RADIO KEYLINE MODIFICATION

SCOPE: This modification applies to all Sigtronics intercom (SPA-, SDB-, SCI-, Sport-) installations that will utilize both pilot and co-pilot transmit positions. See alternate solution if using pilot only transmit position.

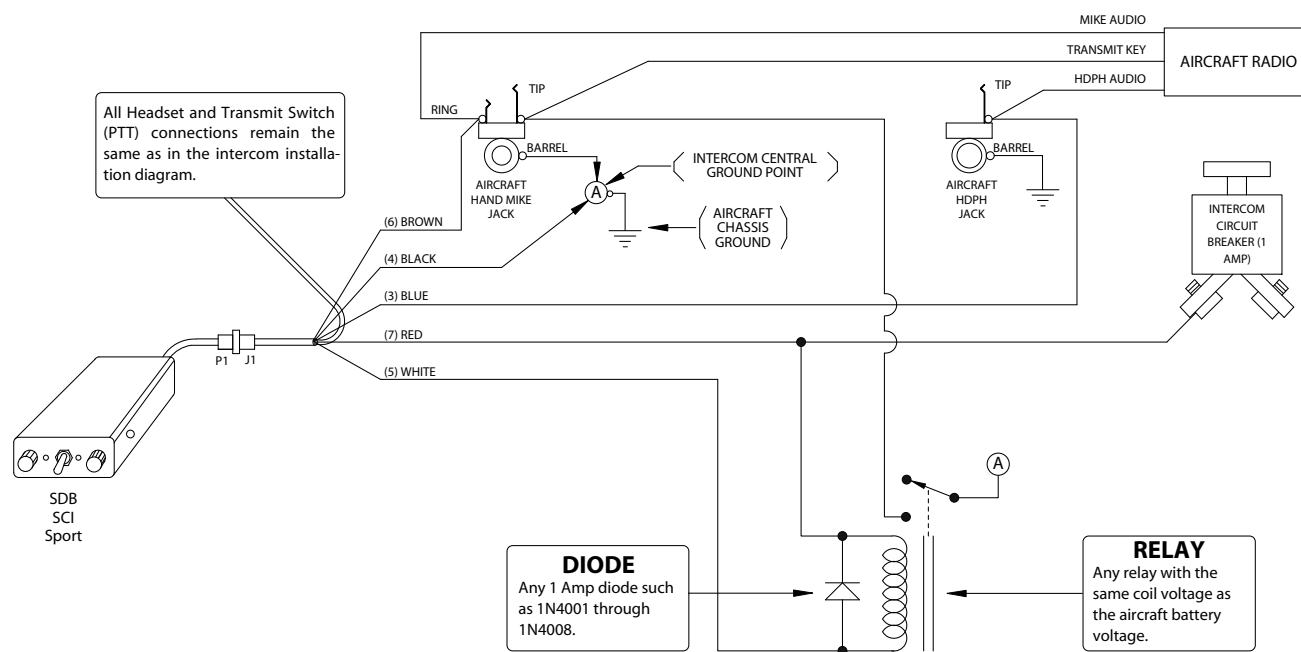
PROBLEM: The radio will not key up when either pilot or co-pilot PTT is pressed. This is due to the 0.7 volt diode drop within the intercom. Common installations affected are usually involved with the KMA-20 audio panels.

VERIFICATION: Check to make sure all wiring and terminal connections are correct and unbroken. The radio will key up from the aircraft hand mike. Shorting the white wire (pin 5) to ground will key up the aircraft radio. The radio will not key from either PTT position. Shorting the white / red (pin 2) or the white / blue (pin 10) will not key the aircraft radio.

SOLUTION: A relay can be added to the installation that will eliminate the 0.7 volt diode drop. Follow the wiring diagram below.

Alternate Solution: For pilot only transmit installations. The pilot's PTT switch can be directly tied to the tip terminal of the aircraft hand mike jack. The PTT switch will still be connected to the white / red (pin 2) wire. The white (pin 5) wire will still be connected to the tip terminal of the hand mike jack.
